Submission to Central Precinct rezoning proposal

The City has reviewed the draft Explanation of Intended Effects (EIE), Design Guide, Planning Report, and supporting technical studies. **The City objects to the following aspects of the proposal**, which need to be more fully resolved to position development at Central Precinct for long term success:

Figure 3. Analysis of how the masterplan has been derived

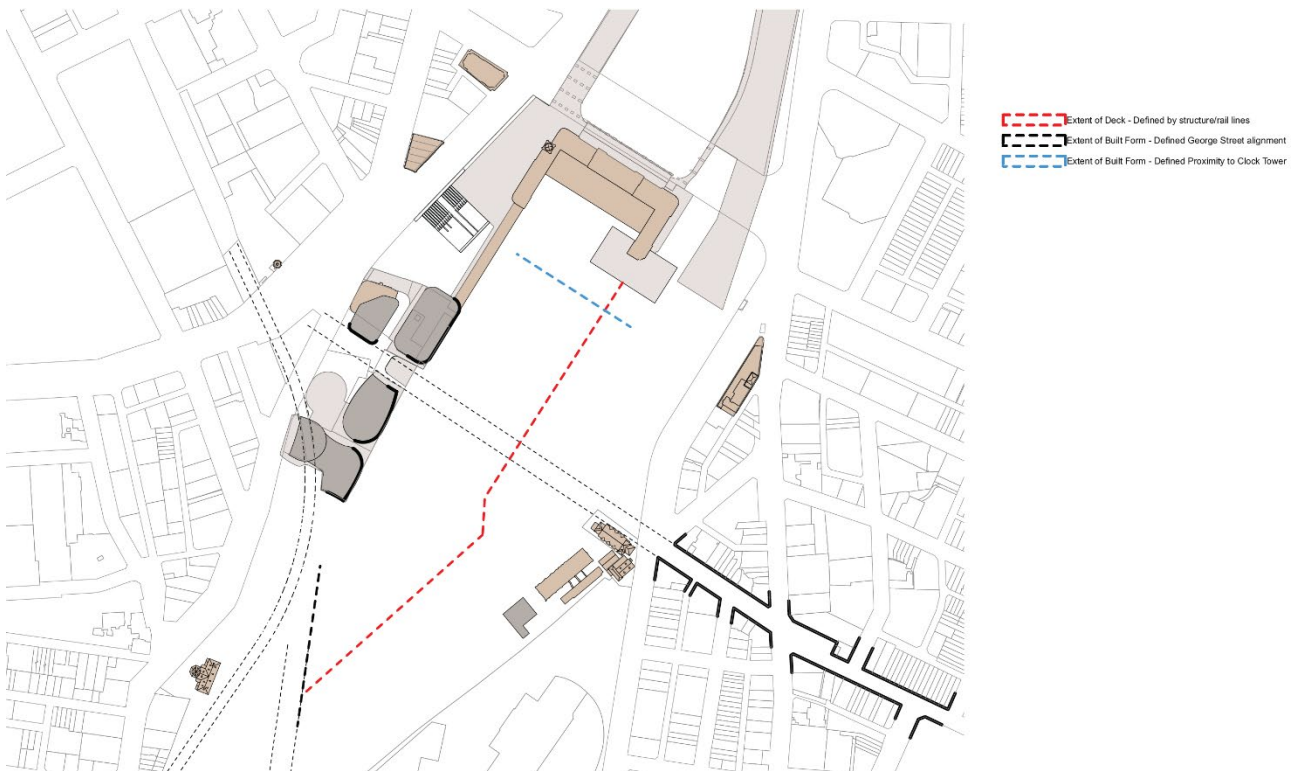
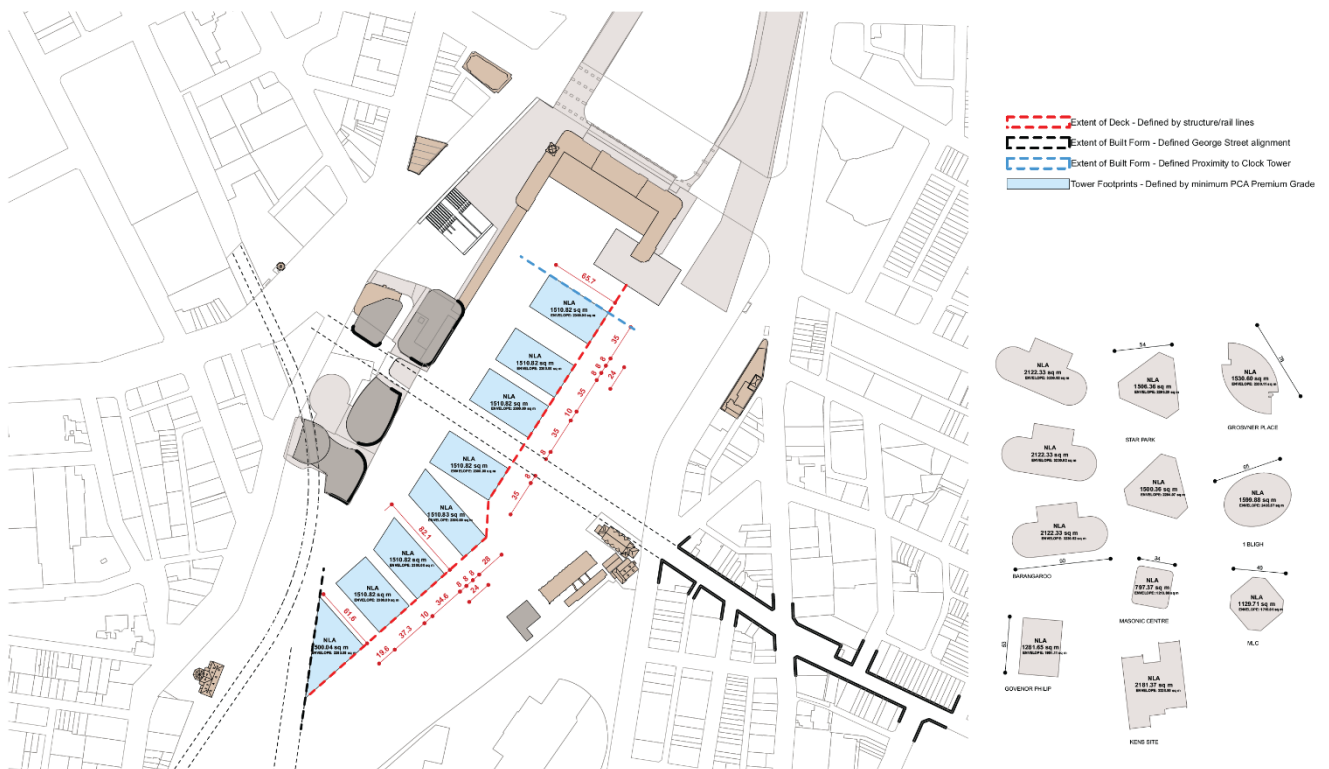
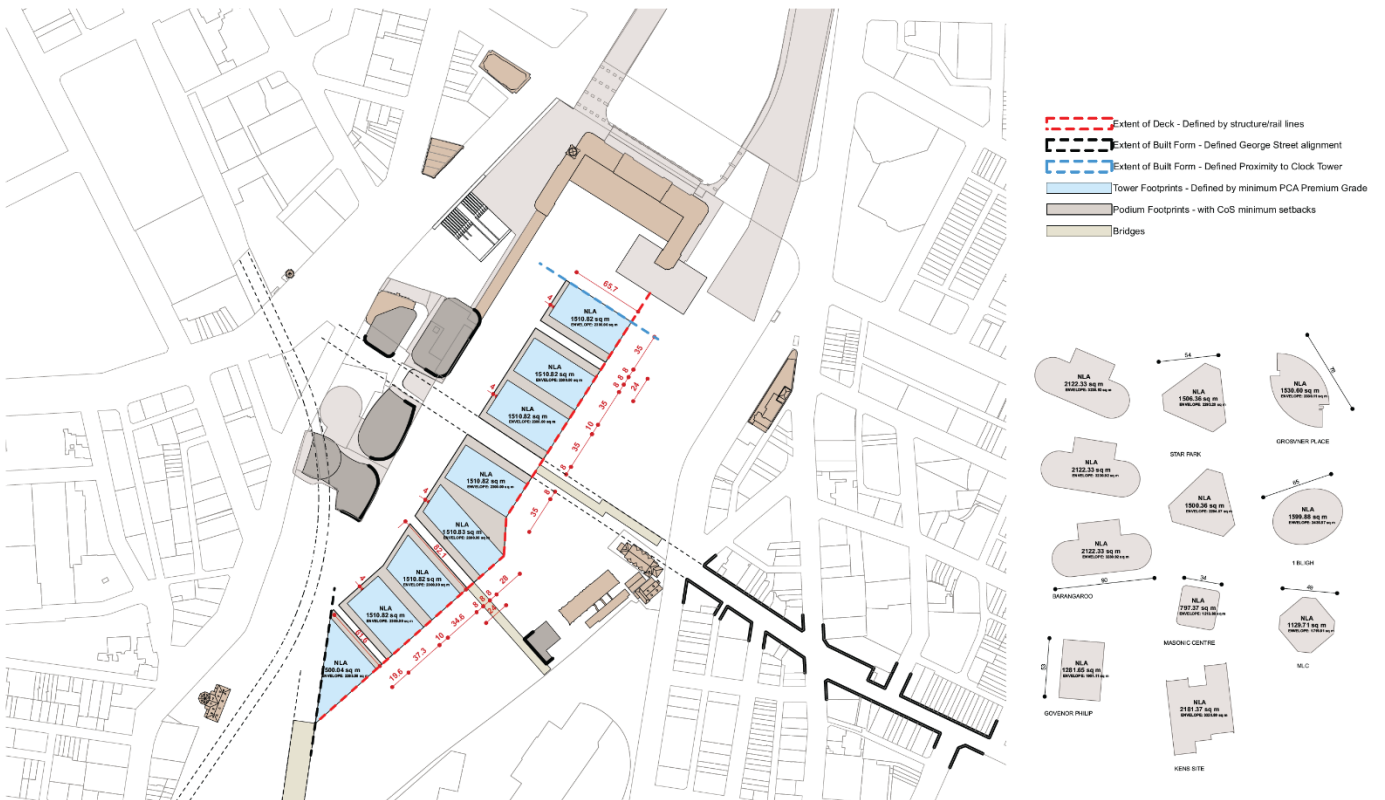
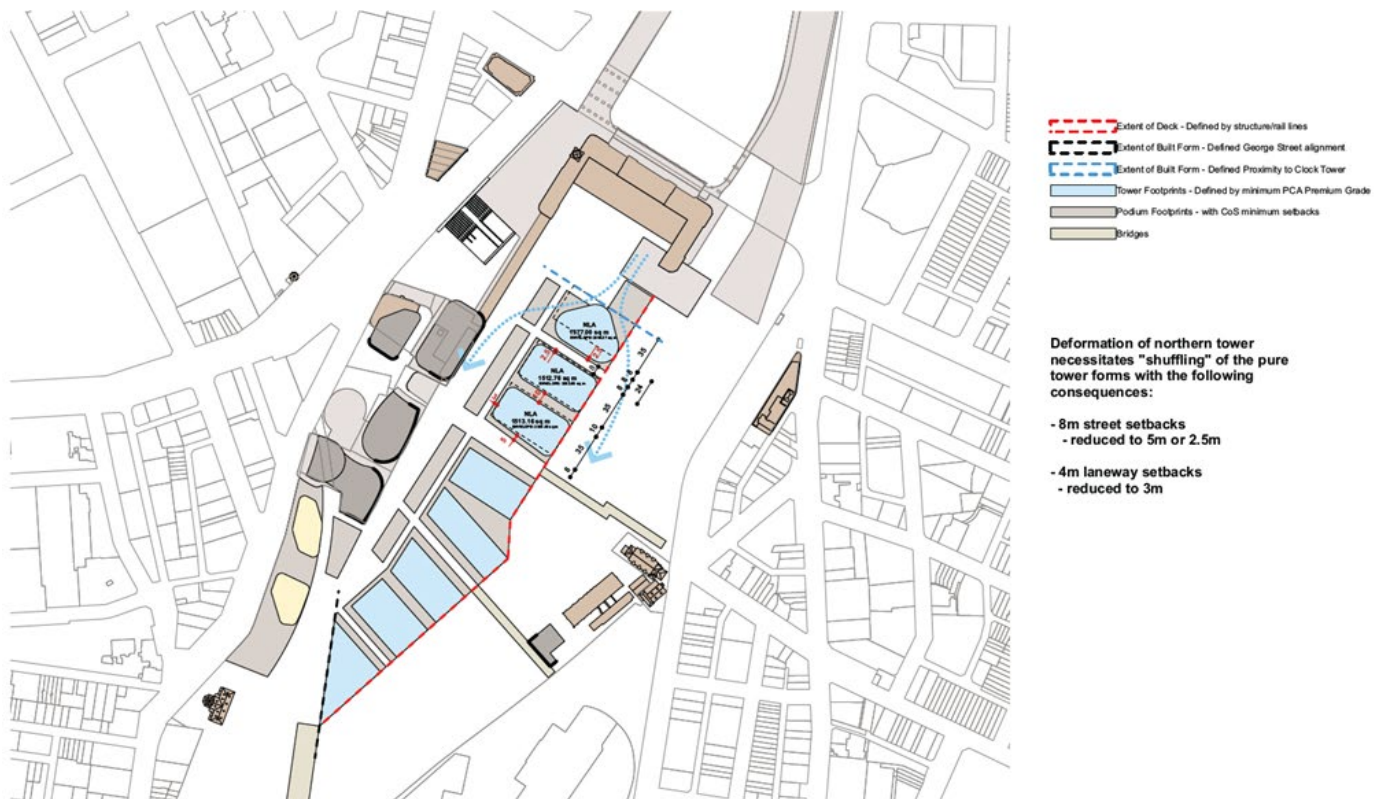
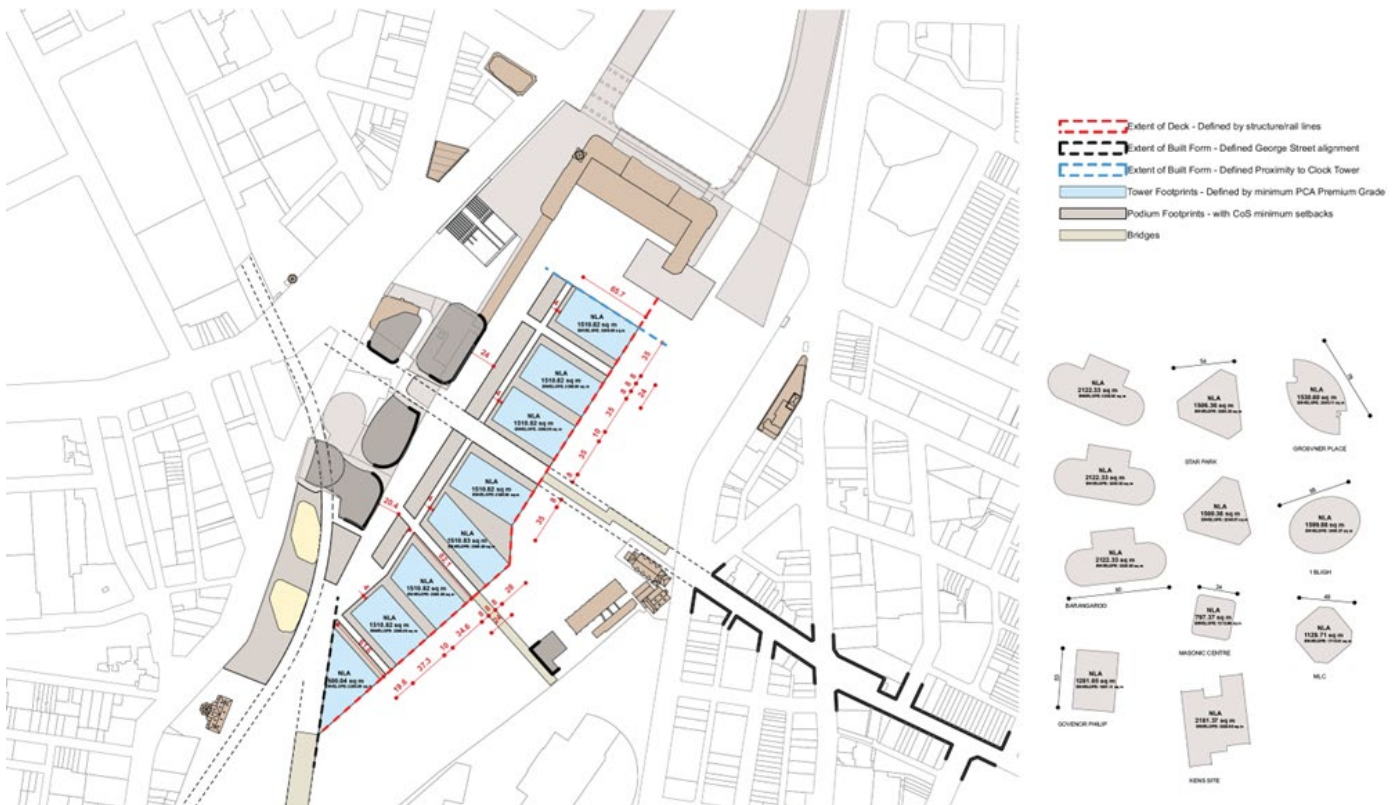
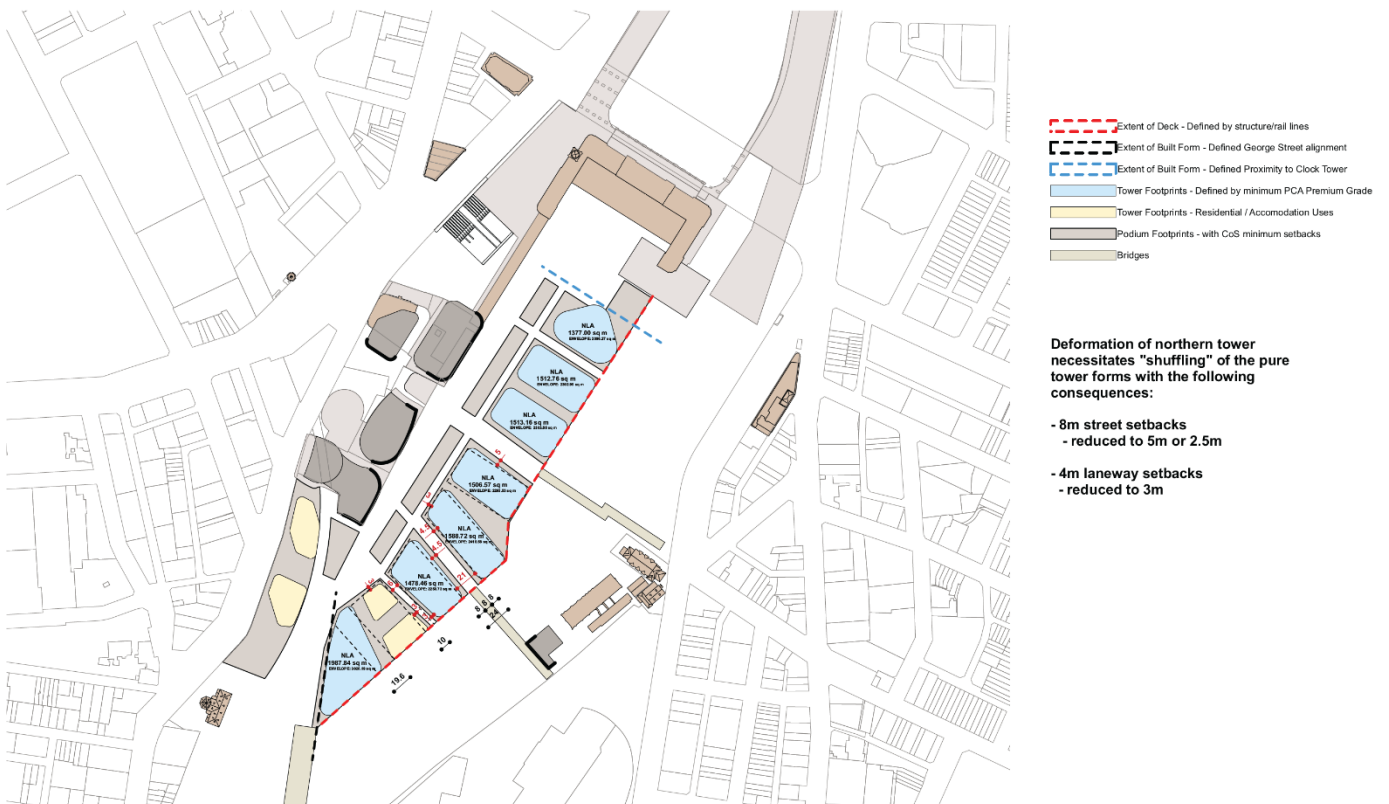
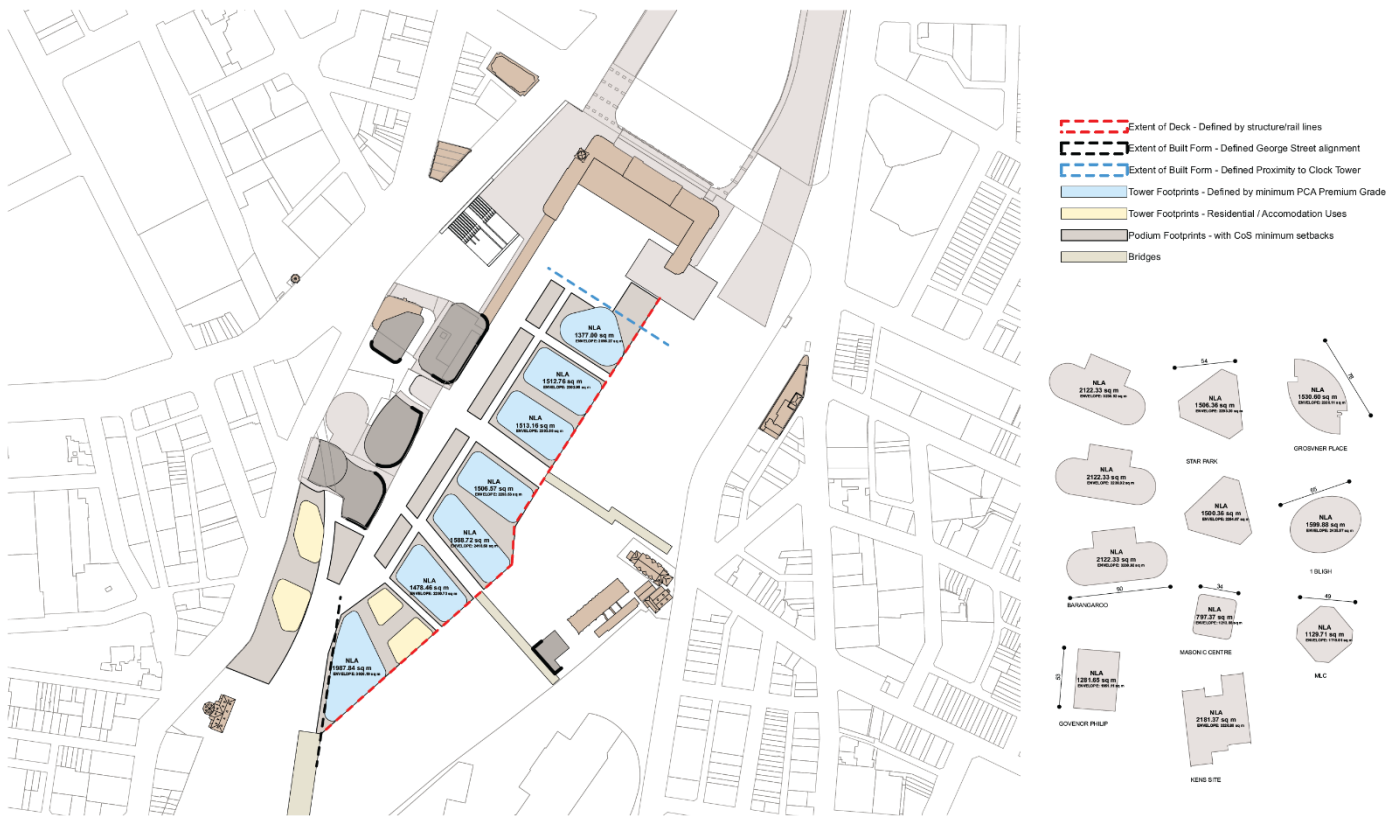
The proposed masterplan has been derived from a principle of optimising premium grade commercial floorplates, illustrated in Figure 3. This results in too many towers, that are too close together at the expense of the public realm. It results in streets and open spaces that have poor sunlight and poor wind conditions, and connections from the surrounding streets and spaces that are narrow, steep and not legible.

Figure 4. Exhibited reference design breaks the sun access plane

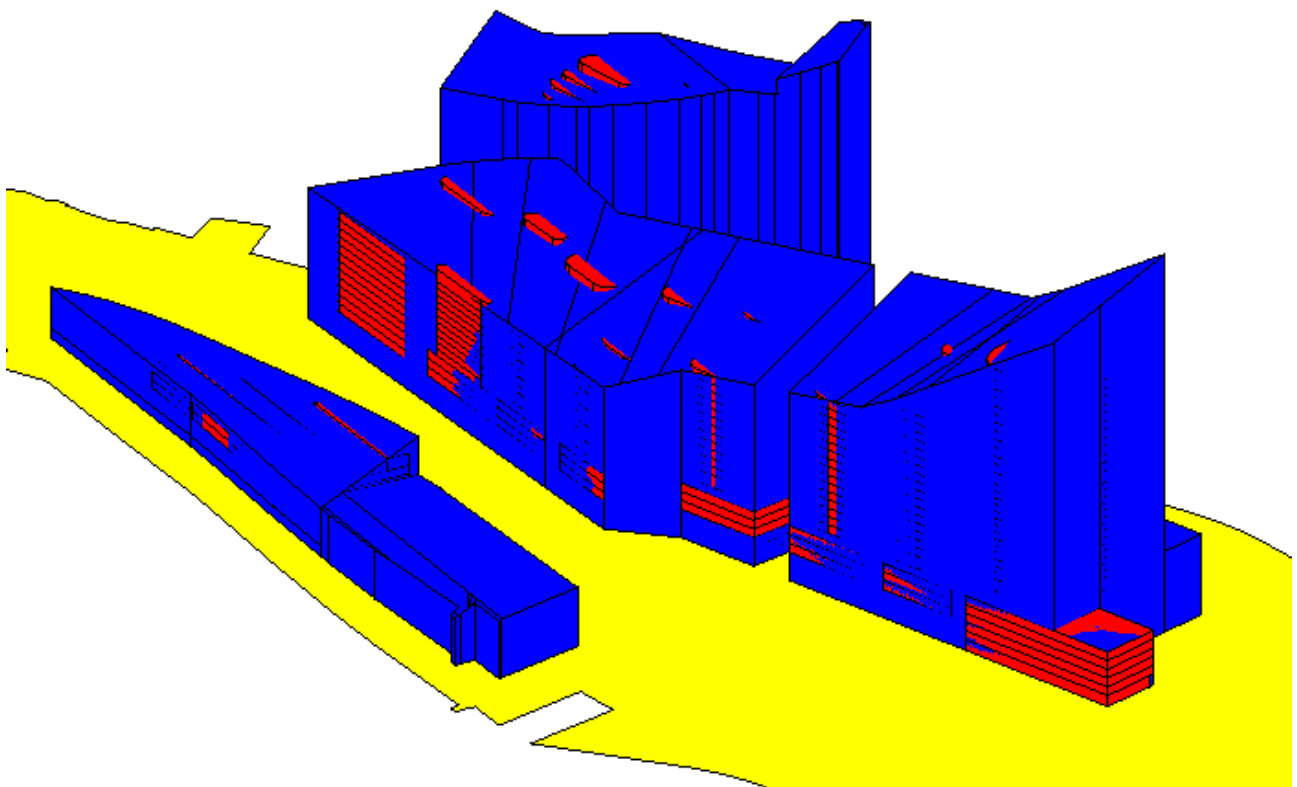
It is also noted that the building envelopes exhibited break the Sun Access Planes in several locations as shown in Figure 4. The building heights must be reduced, and the GFA re-calculated.

Figure 10. Sunlight to Mortuary Station Plaza

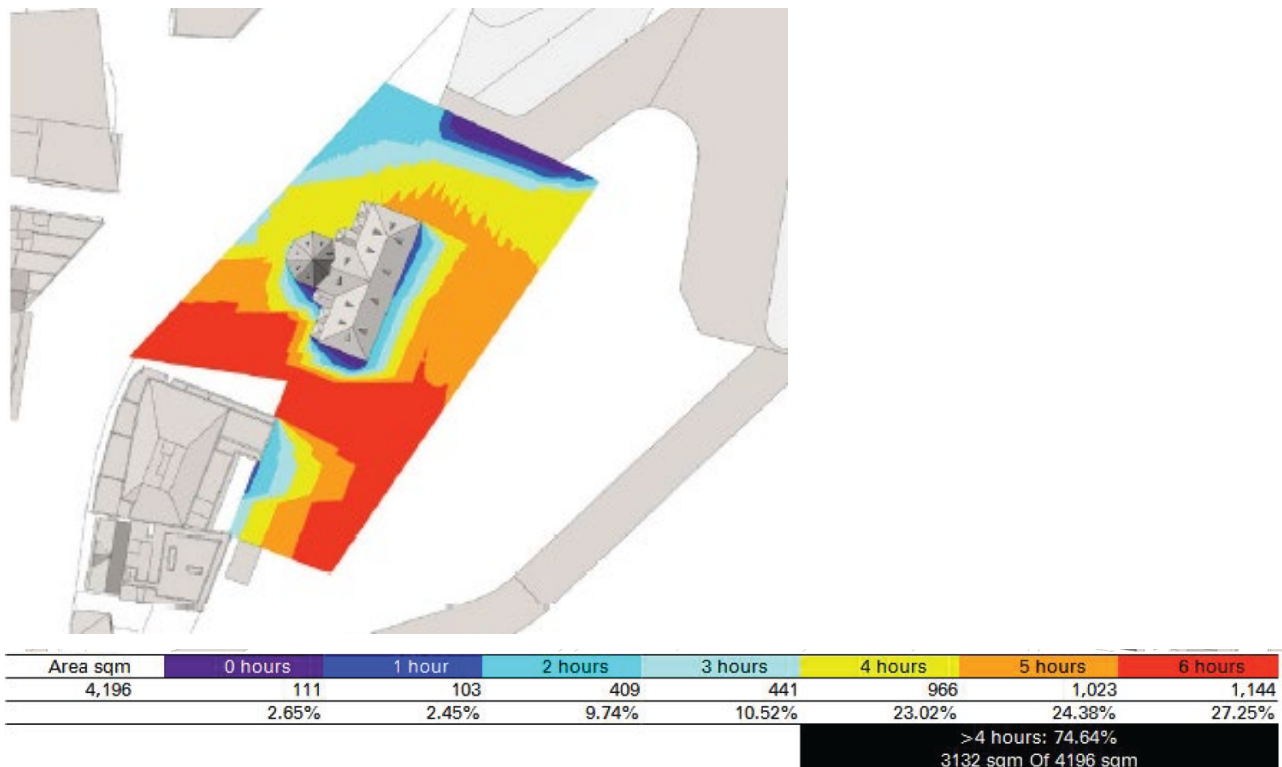
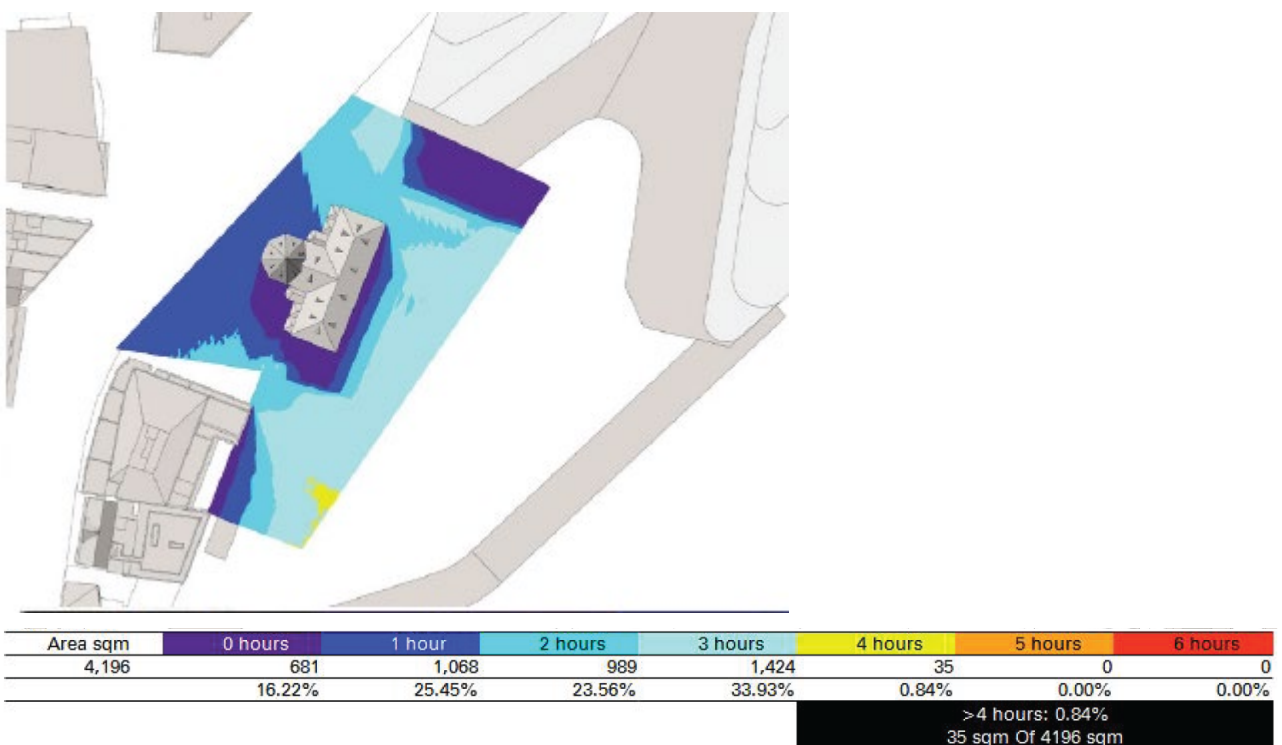
- access from the OSD to the Mortuary station Plaza is awkward
- there is insufficient sunlight for significant tree growth as shown in Figure 10
- the design must accommodate heritage trains into the future.

74% of public space receives >4hours of sun at the Equinox (March/ September)

0.84% of public space receives >4 hours of sun at the Solstice (June)
